8802050154 880201
PDR ADDCK 05000400
PDR

SHEARON HARRIS NUCLEAR POWER PLANT
NRC DOCKET NO. 50-400
OPERATING LICENSE NPF-63
REQUEST FOR LICENSE AMENDMENT

BASIS FOR CHANGE REQUEST
INCREASED F-DELTA-H MULTIPLIER

FIGURE 3.2-1
 AXIAL FLUX DIFFERENCE LIMITS AS A FUNCTION OF
 RATED THERMAL POWER FOR RAOC

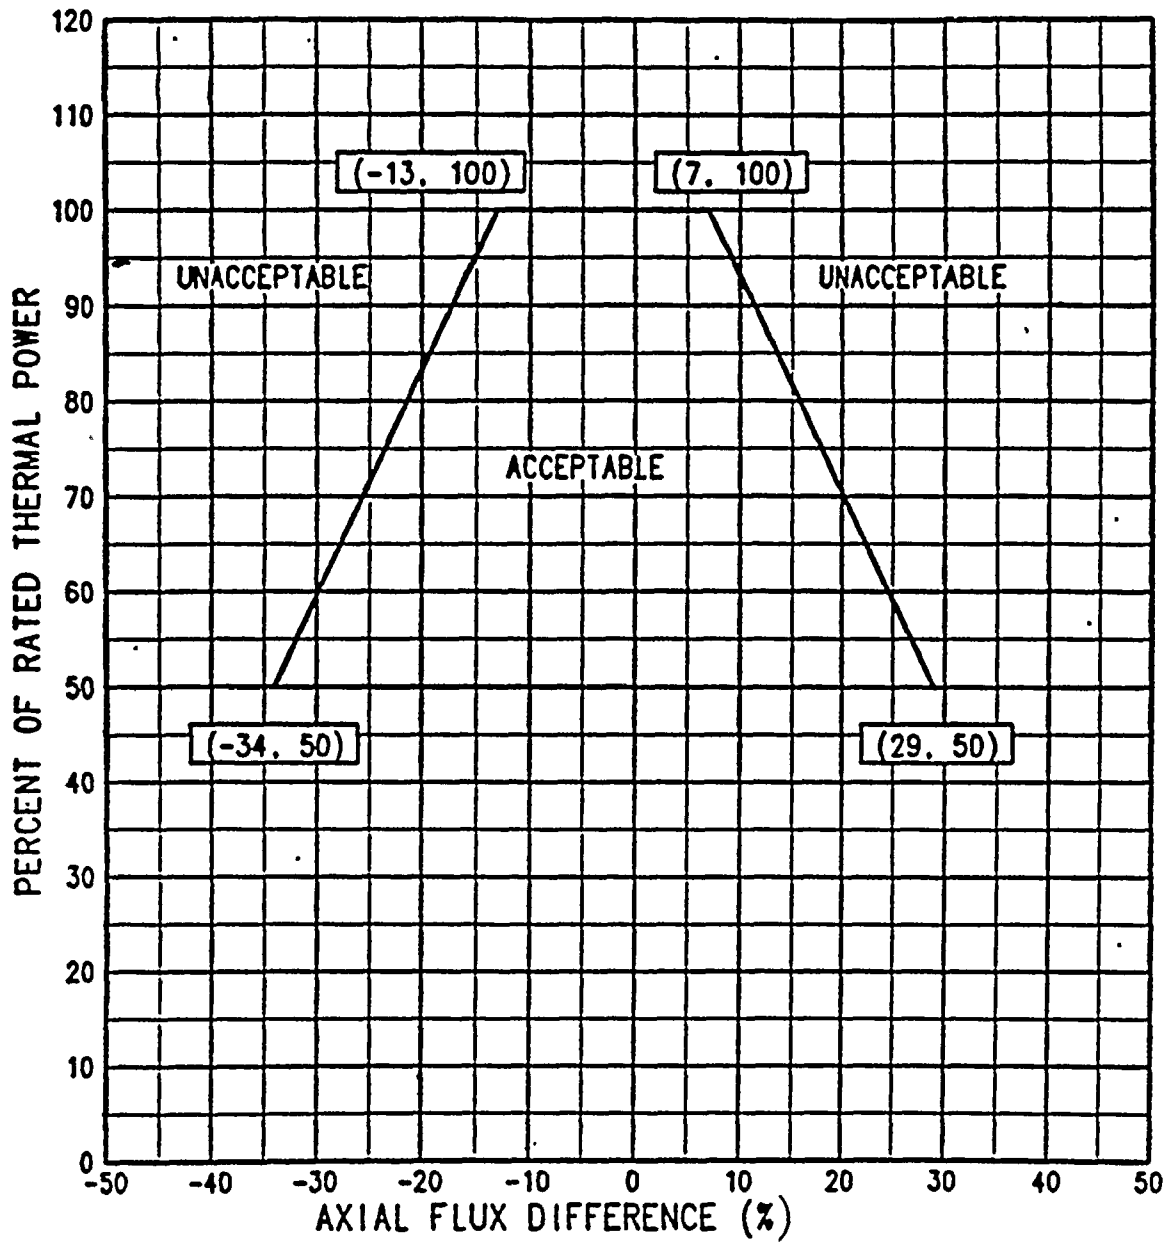
Replace Existing Pages 3/4 2-1 Through 3/4 2-8
With the Attached

- a. the acceptable operational space defined by Figure 3.2-1 for Relaxed Axial Offset Control (RAOC) operation, or
- b. within a ± 3 percent target band about the target AFD during Base Load operation.

- a. For RAOC operation with the indicated AFD outside of the Figure 3.2-1 limits, either:
 1. Restore the indicated AFD to within the Figure 3.2-1 limits within 15 minutes, or
 2. Reduce THERMAL POWER to less than 50% of RATED THERMAL POWER within 30 minutes and reduce the Power Range Neutron Flux - High Trip setpoints to less than or equal to 55% of RATED THERMAL POWER within the next 4 hours.
- b. For Base Load operation above APL^{ND**} with the indicated AXIAL FLUX DIFFERENCE outside of the applicable target band about the target AFD, either:
 1. Restore the indicated AFD to within the target band limits within 15 minutes, or
 2. Reduce THERMAL POWER to less than APLND of RATED THERMAL POWER and discontinue Base Load operation within 30 minutes.
- c. THERMAL POWER shall not be increased above 50% of RATED THERMAL POWER unless the indicated AFD is within the Figure 3.2-1 limits.

FIGURE 3.2-2

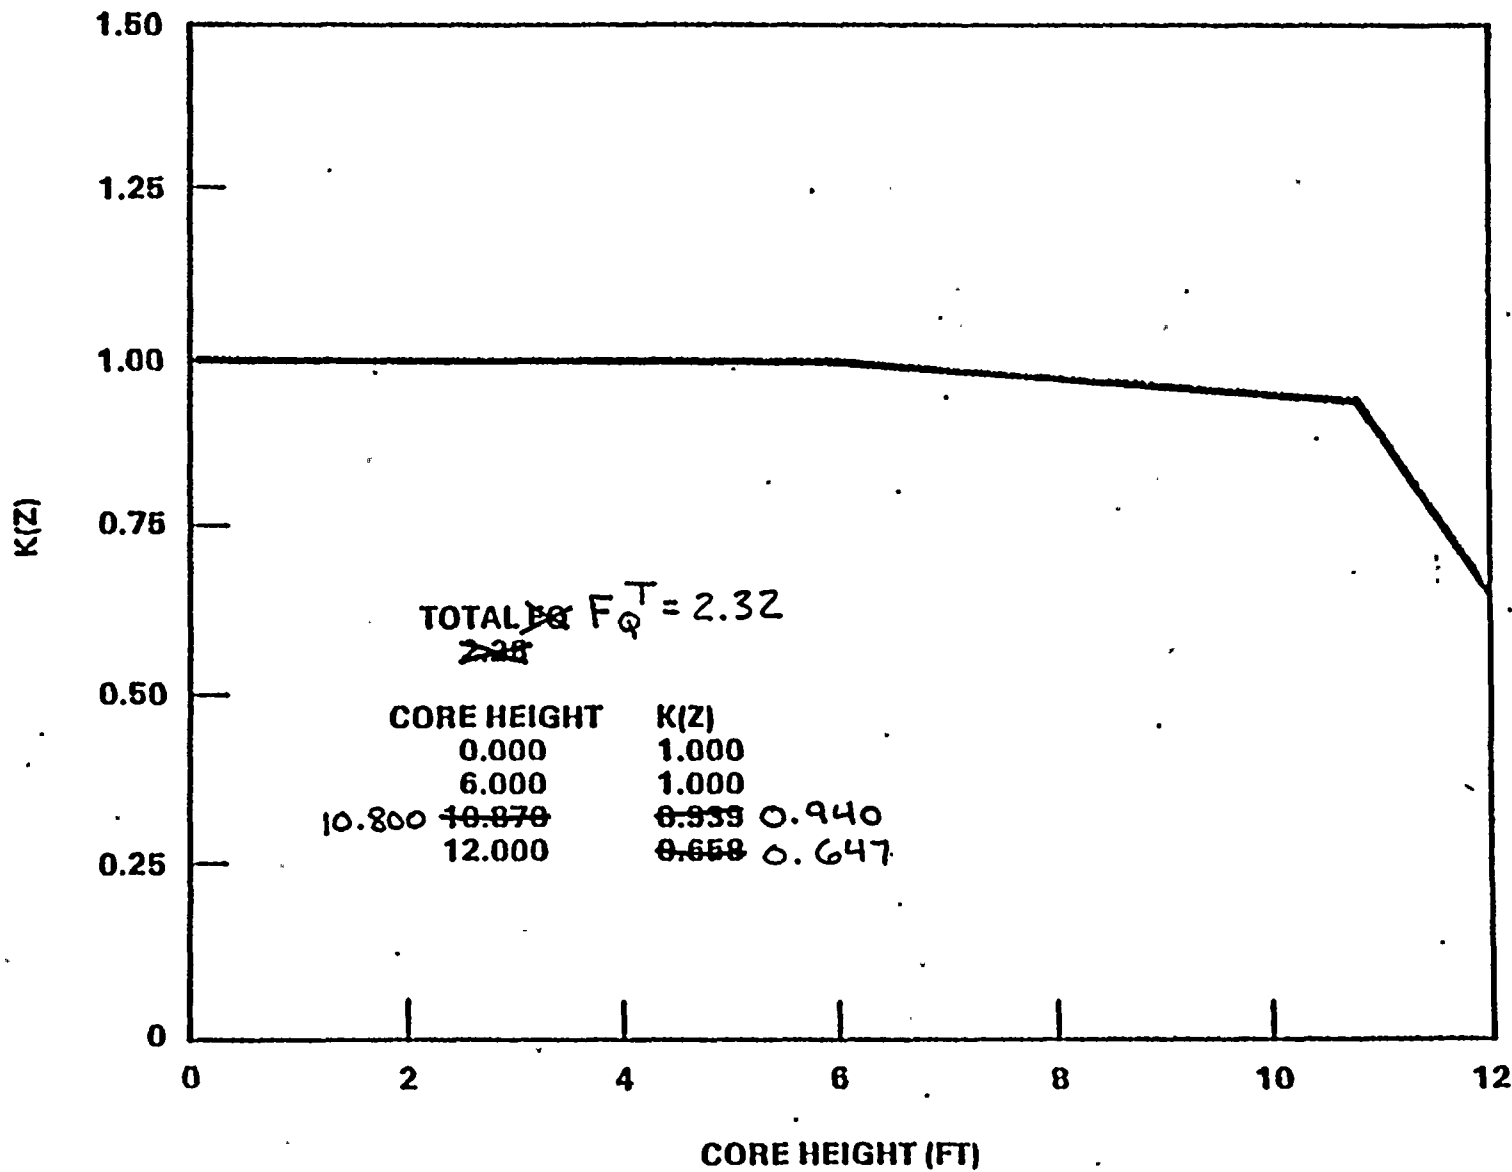
where $F_Q^M(Z)$ is the measured $F_Q(Z)$ increased by the allowances for manufacturing tolerances and measurement uncertainty, 2.32 is the F_Q limit, $K(Z)$ is given in Figure 3.2-2, P is the fraction of RATED THERMAL POWER, and $W(Z)$ is the cycle dependent function that accounts for power distribution transients encountered during normal operation. This function is given in the Peaking Factor Limit Report as per Specification 6.9.1.6.

FIGURE B 3/4 2-1 (DELETED)

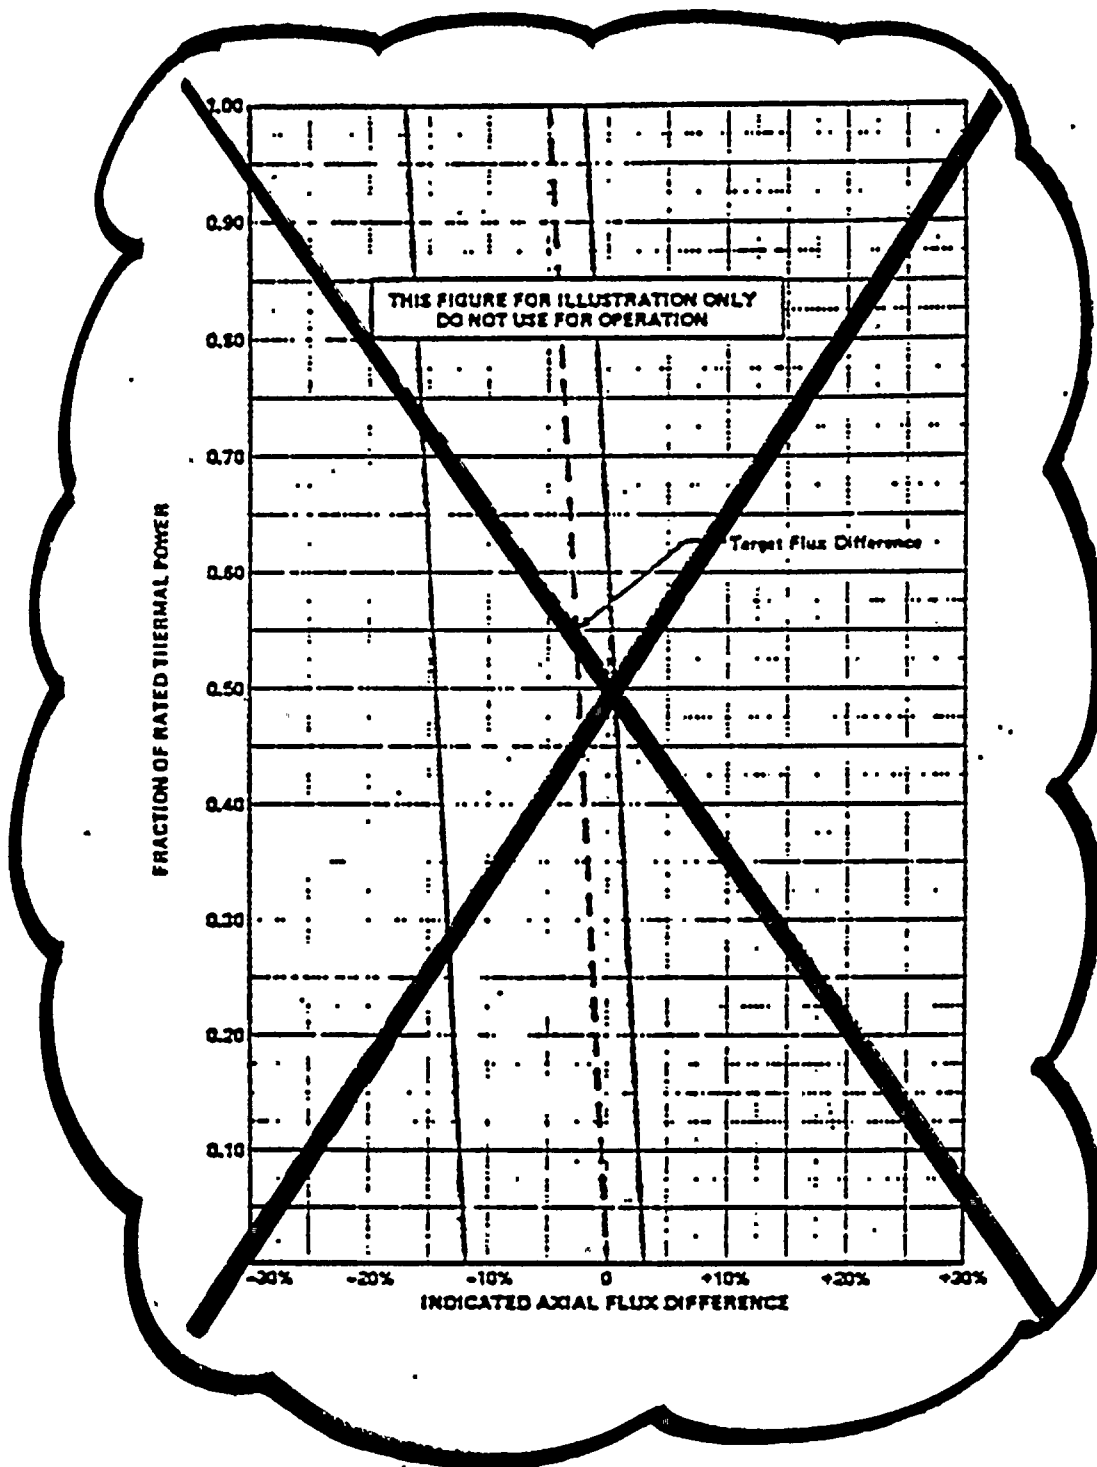
~~TYPICAL INDICATED AXIAL FLUX DIFFERENCE VERSUS THERMAL POWER FOR
BURNUP GREATER THAN 6000 MWD/MTU~~

FIGURE 2.1-1

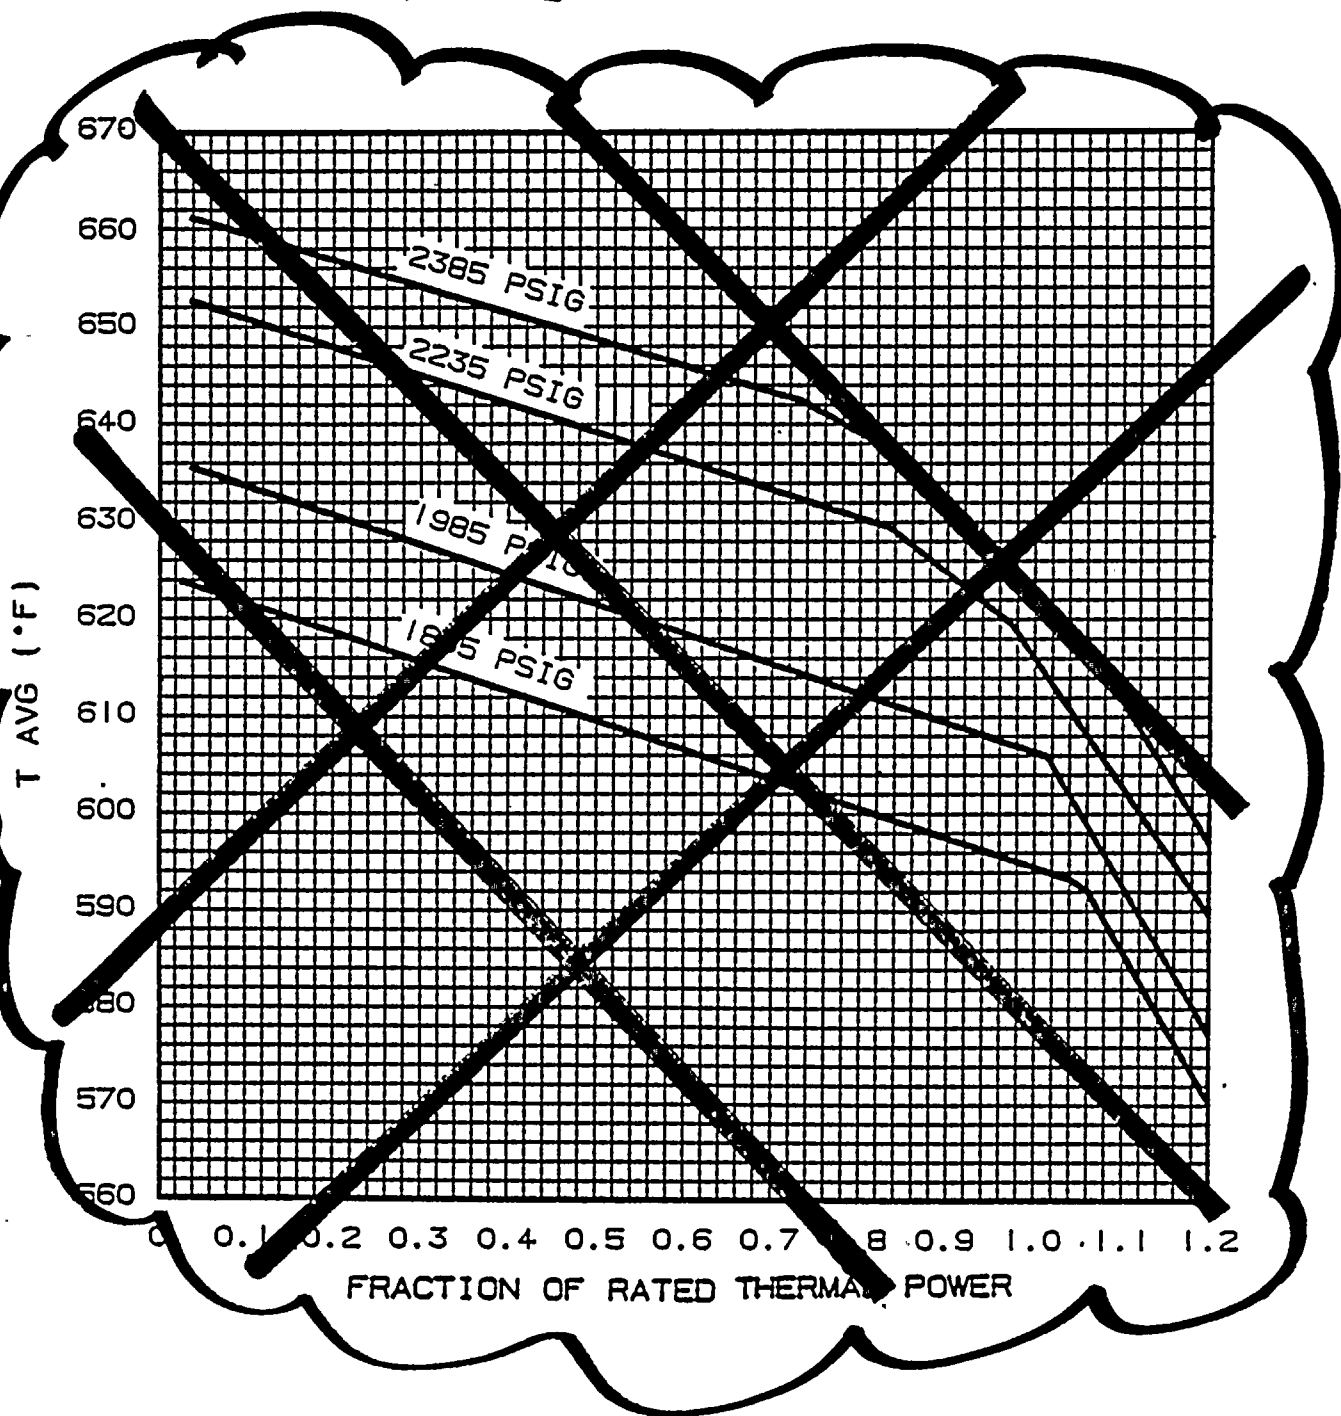
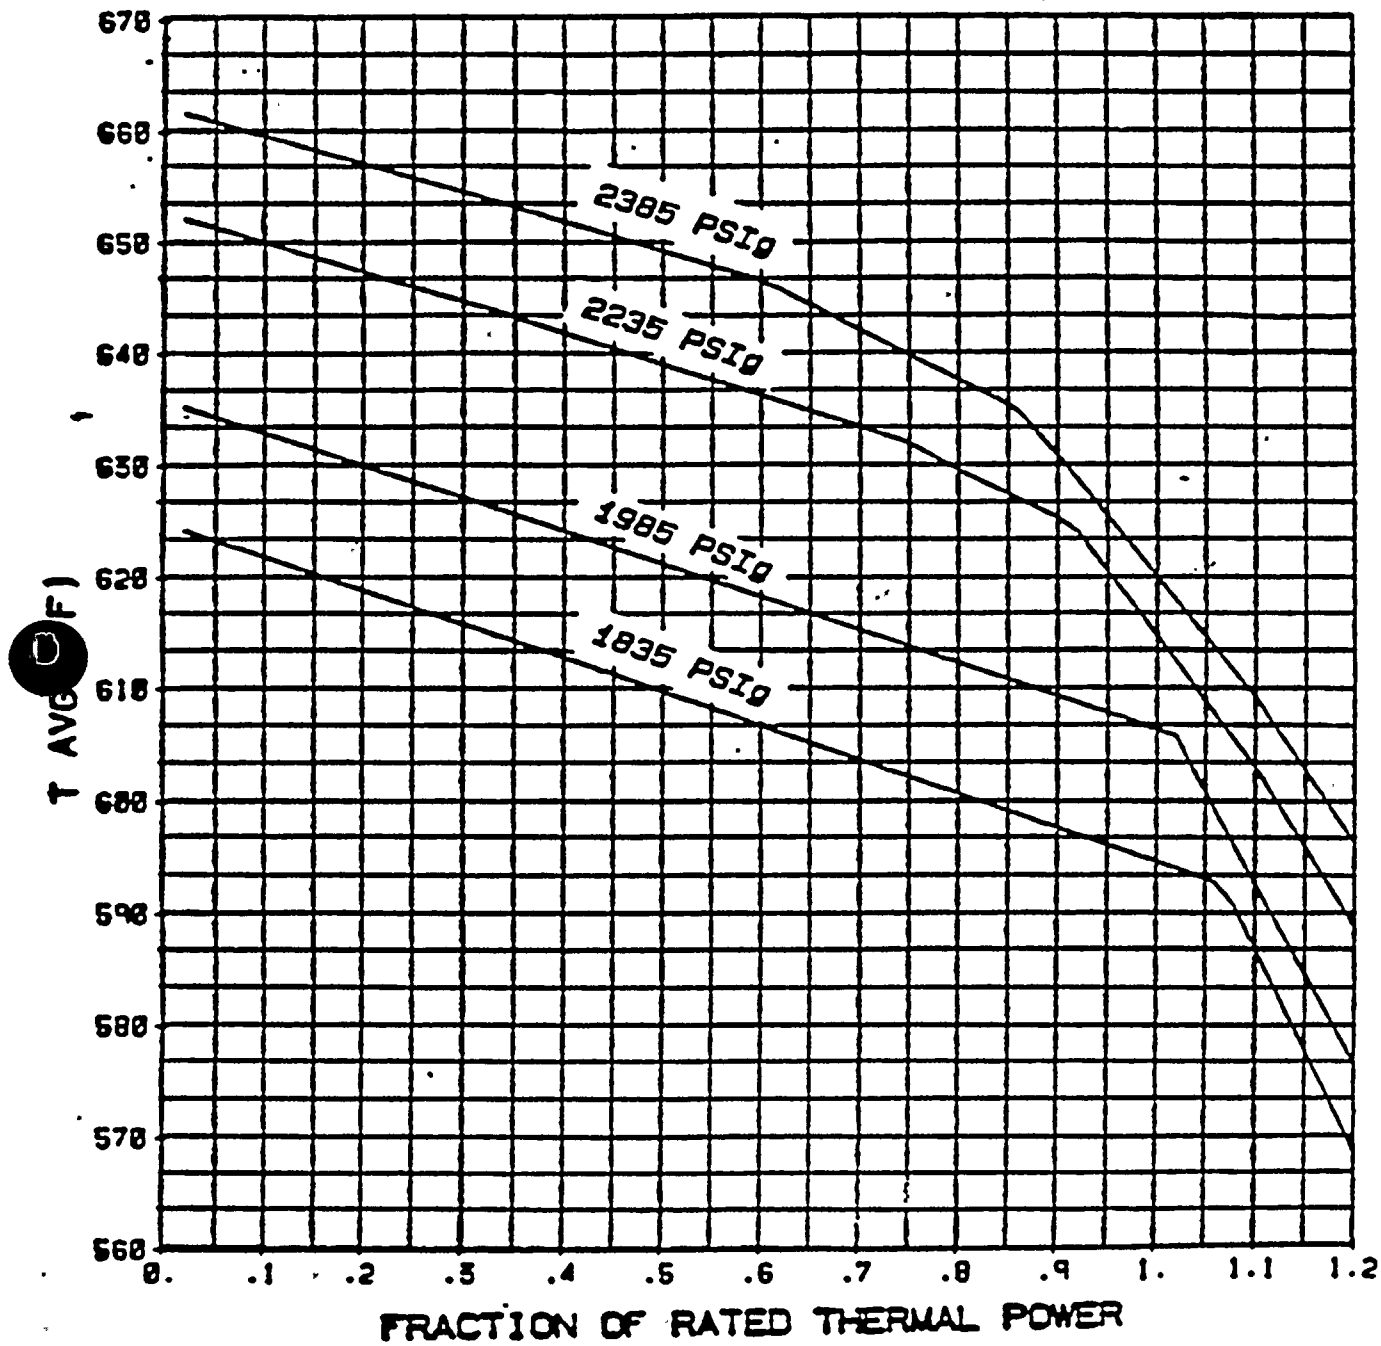
The proposed amendment revises the equation used to determine F-Delta-H, the Nuclear Enthalpy Rise Hot Channel Factor, presented in Technical Specification 3.2.3.b. The existing 0.2 multiplier has been increased to 0.3. This multiplier acts to increase the allowable F-Delta-H at reduced power levels. In addition, the core limit curves presented in Technical Specification Figure 2.1-1 have been revised. These curves, which are based on F-Delta-H, show the loci of points of thermal power, Reactor Coolant System pressure and average temperature for which the minimum Departure from Nucleate Boiling Ratio (DNBR) is no less than 1.30. Similar changes to the F-Delta-H multiplier have been granted for McGuire Units 1 and 2 and Catawba Units 1 and 2.

where P is the fraction of rated thermal power. The proposed amendment replaces the existing 0.2 multiplier with 0.3. Increasing the multiplier from 0.2 to 0.3 increases loading pattern flexibility and allows deeper rod insertion at low power levels. As a result of the increased F-Delta-H multiplier the core limit curves presented in Technical Specification Figure 2.1-1 have been revised. These curves, which are based on F-Delta-H, show the loci of points of thermal power, Reactor Coolant System pressure and average temperature for which the minimum DNBR is no less than 1.30.

rely on the OTAT/OPAT setpoints for protection may be impacted by the increase in the F-Delta-H multiplier. Since a power dependent value of F-Delta-H is assumed in the generation of the core limits, the increase in F-Delta-H at reduced power will result in a change to the core limits below 100% power. The existing OTAT/OPAT setpoints have been compared to the revised core limits which include the F-Delta-H multiplier increase. It was determined that the existing setpoints continue to protect the core limits, and thus events which rely on the OTAT/OPAT setpoints for protection are not impacted by this change. Therefore, the conclusions of the non-LOCA analyses presented in the SHNPP FSAR remain valid.

INSERT FOR FIGURE 2.1-1
